**GIS Drain Input Checklist**

**Drain Name:** Anchorage

Re: **Anchorage Drain - Sec. 1 Arm**  
**Revised Report \*\***

# Storm Sewer As-Builts

**Storm Sewer Extention - Lot 16/17**

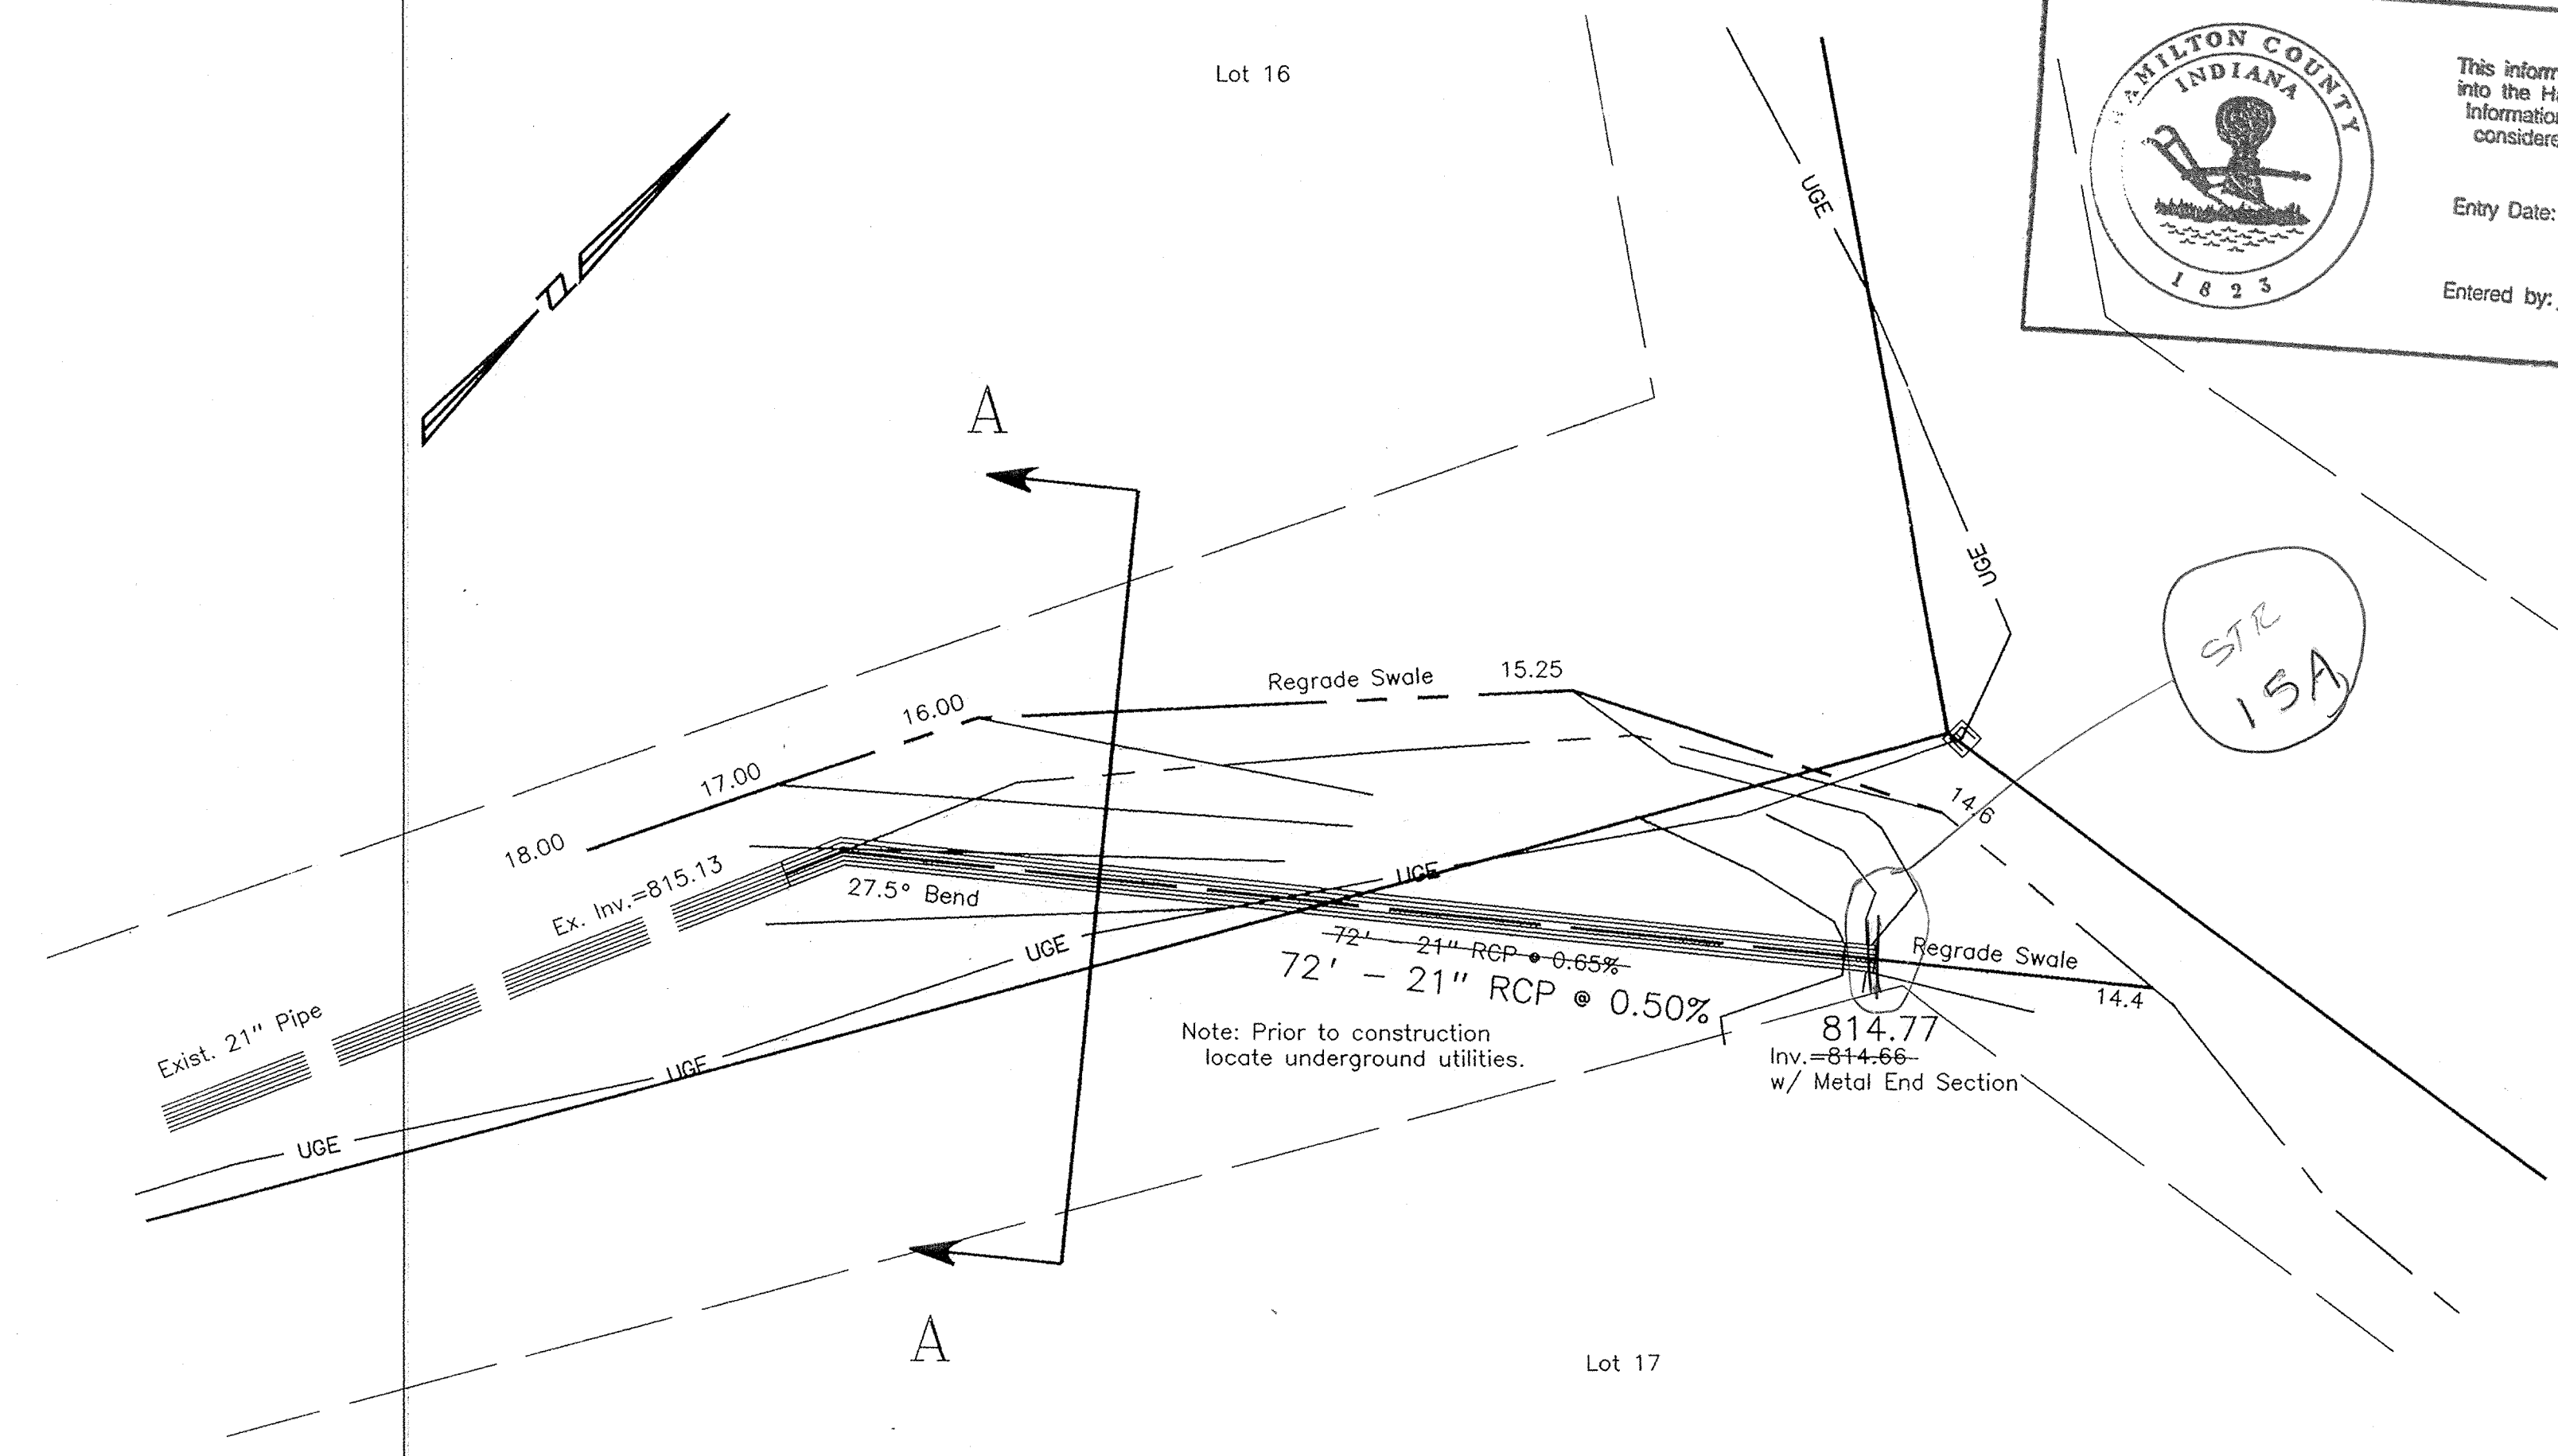
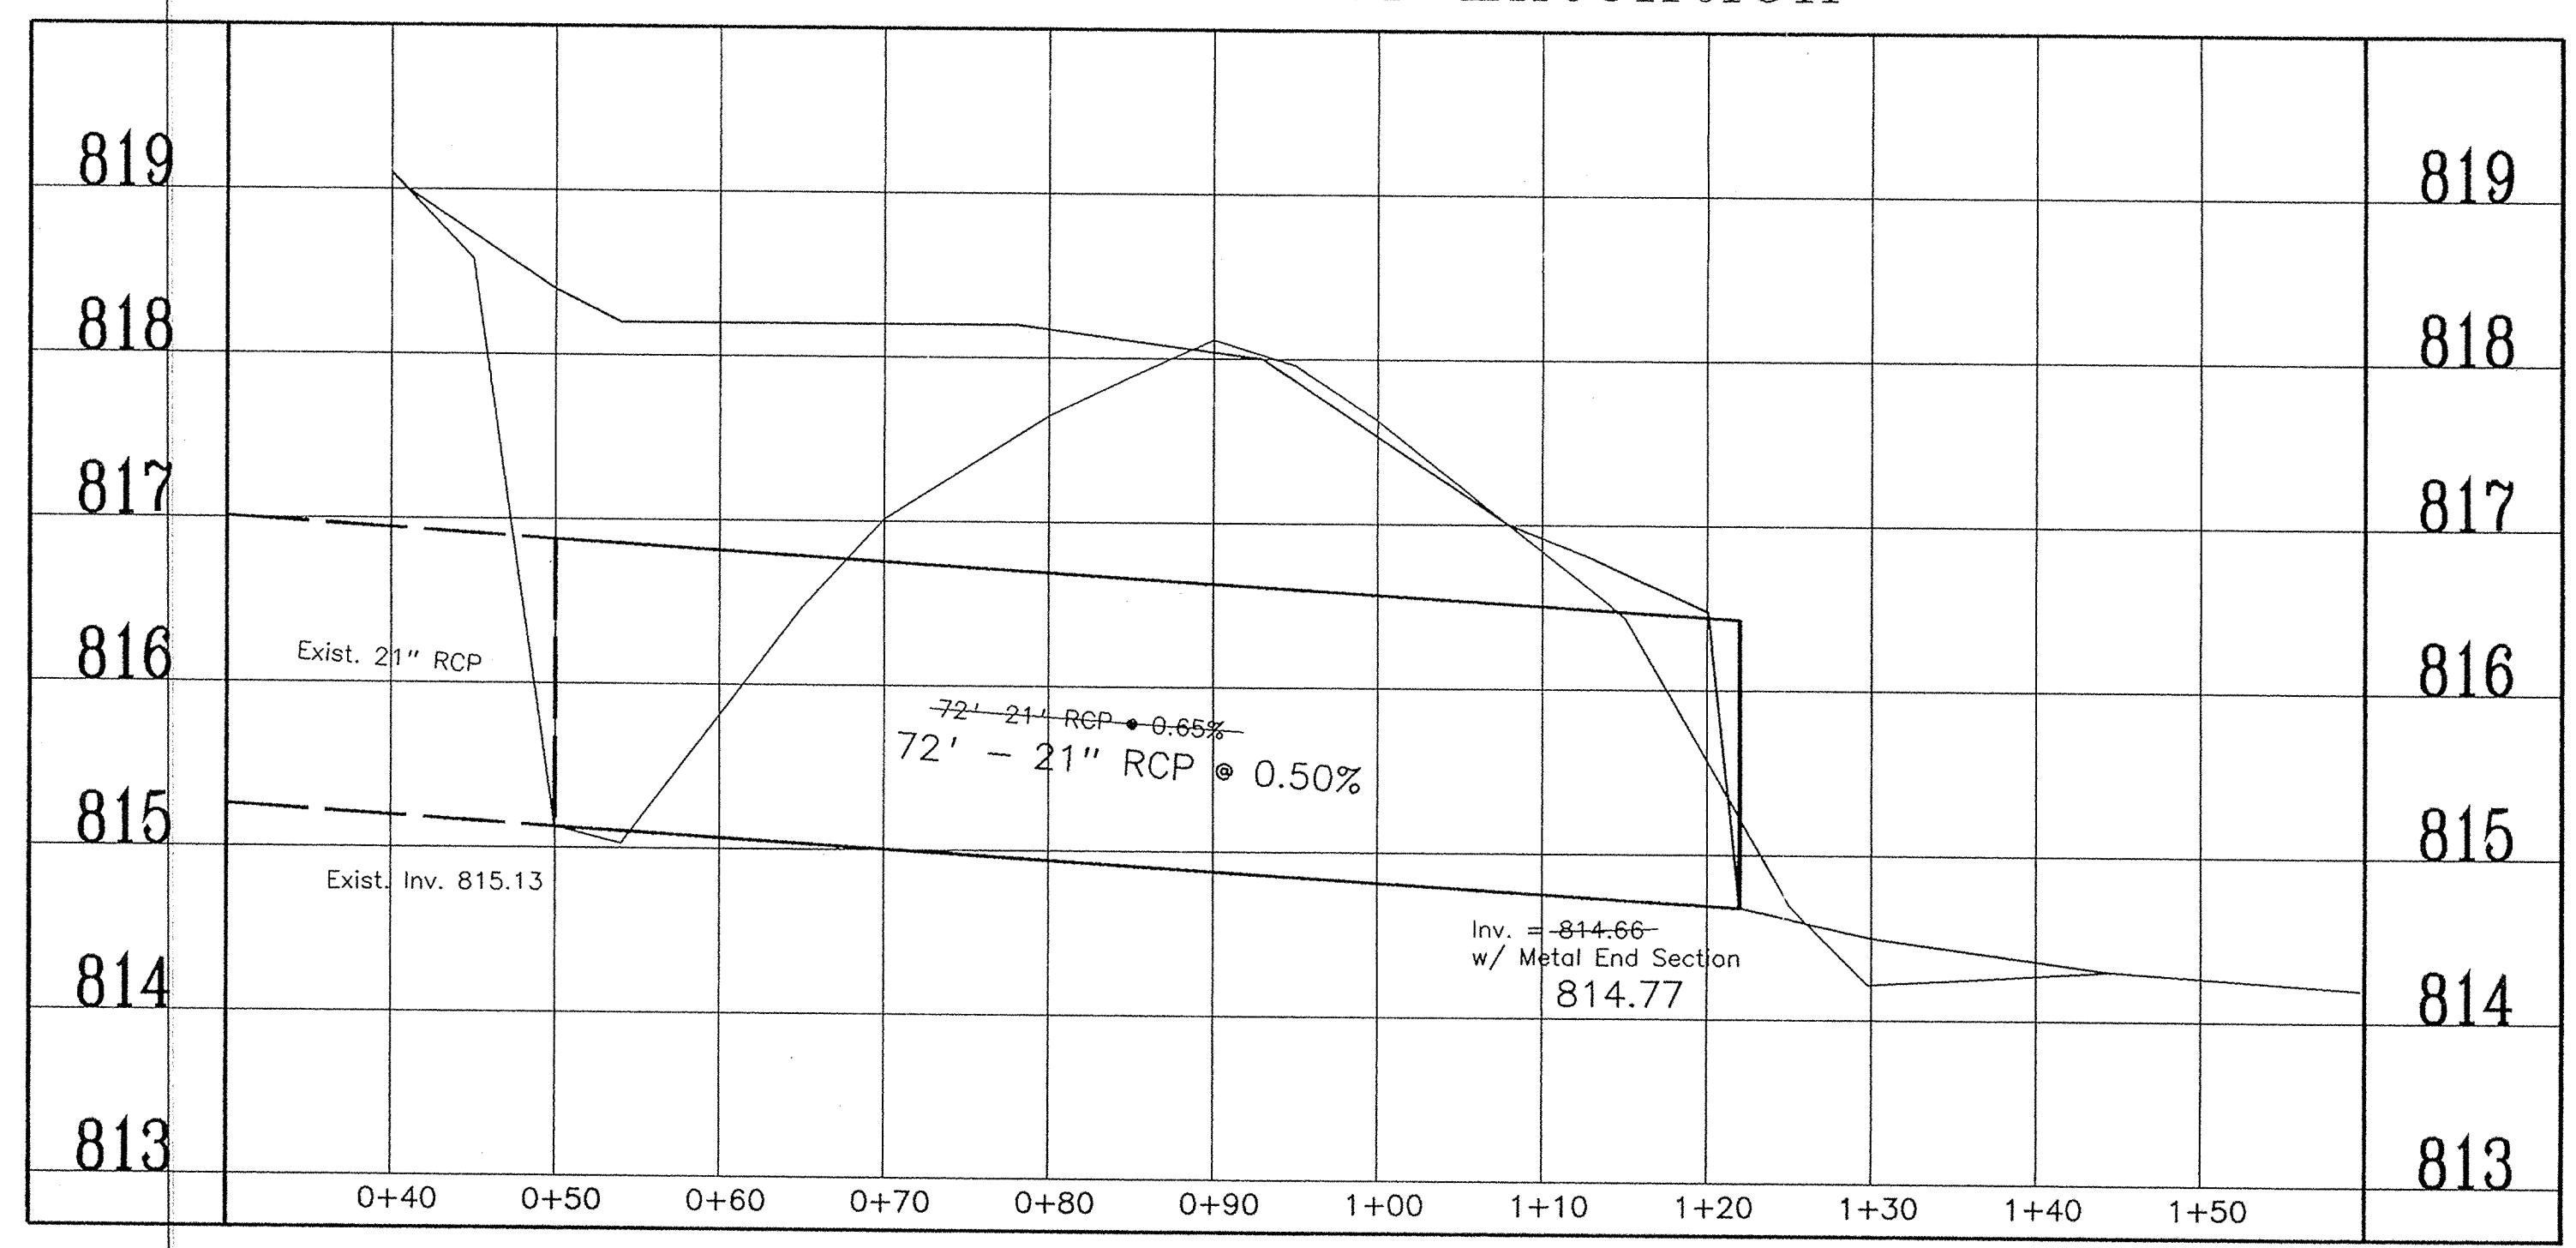
Structure 36-MES was extended from 30' feet to 90' feet. This portion is noted on the asbuilt sheet provided by Falcon Engineering and labeled "Exhibit A."

Structure 36-MES was extended from 30' feet to 90' feet. This portion is noted on the asbuilt sheet provided by Falcon Engineering and labeled "Exhibit A."

820				820
815	Exist. STR# 36 Solid Lid MH TC = 815.75		STR# 36A Conc. End Sect.	815
810	Exist. 15" Pipe			810
805	90' - 15" PVC @ 6.20%			805
800				800
		0+00	0+50	1+00
